**REVISION 004 TO AN INVITATION TO TENDER**

<b>Title:</b> Construct an Energy Efficient Duplex in Pond Inlet	
<b>Solicitation No.:</b> 5P468-22-0003/A	<b>Date:</b> September 12, 2022
<b>Amendment No.:</b> 004	
<b>Client Reference No.:</b> N/A	
<b>GETS Reference No.:</b> PW-22-00999981

## Amendment 004

**Q1.** REF Roof Sheathing

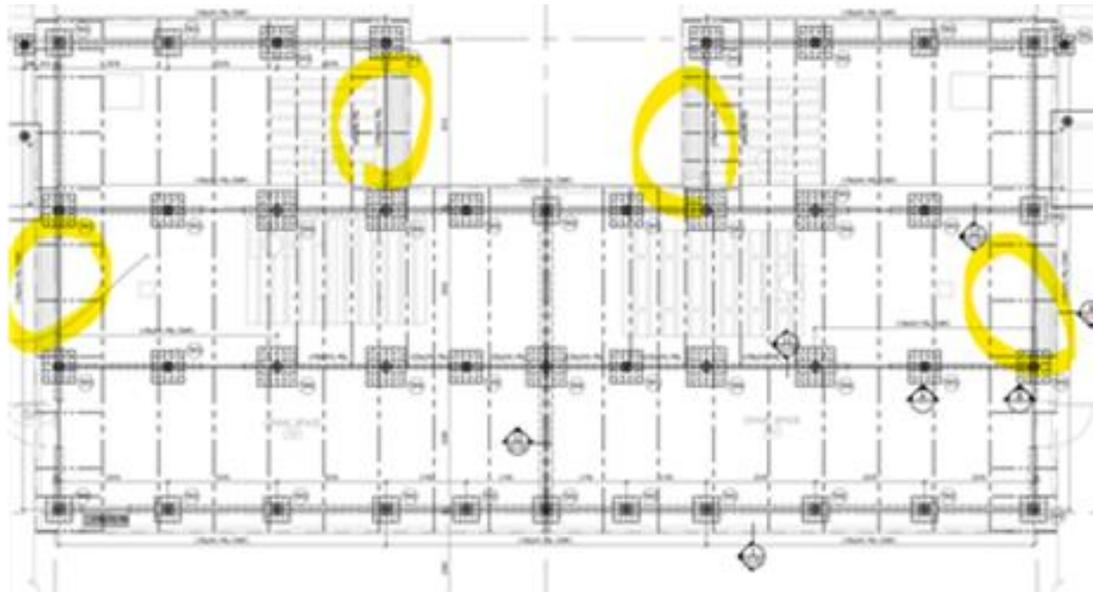
On drawing A0.01 for the roof assemblies R1 and R2 the plywood sheathing under the SIP panel is 13 mm but the Wood Frame description on S1.01 states for a minimum 16 mm plywood for roof.

**A1.** 16 mm plywood sheathing for sloped roof.

**Q4. REF** Drawing S2.02

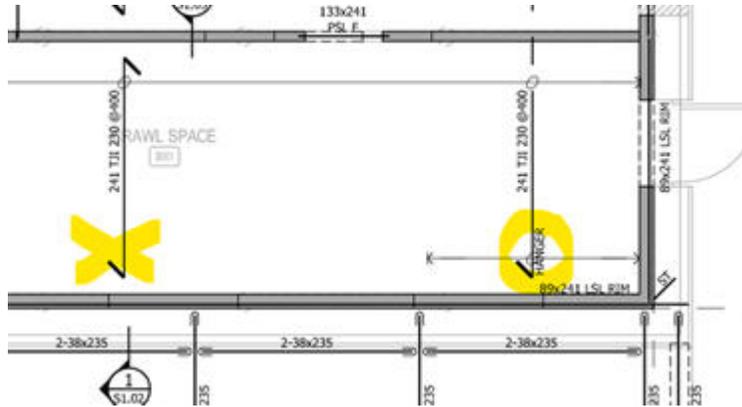
Please confirm the size of the rim board not shown on grid A and on grid 2.  
Are the hanger for TJI required only where indicated ?

- A4.** Correct, hangers only required where indicated along gridline 3.  
Rim joist along gridline A and 2 should also be 89x241 LSL.
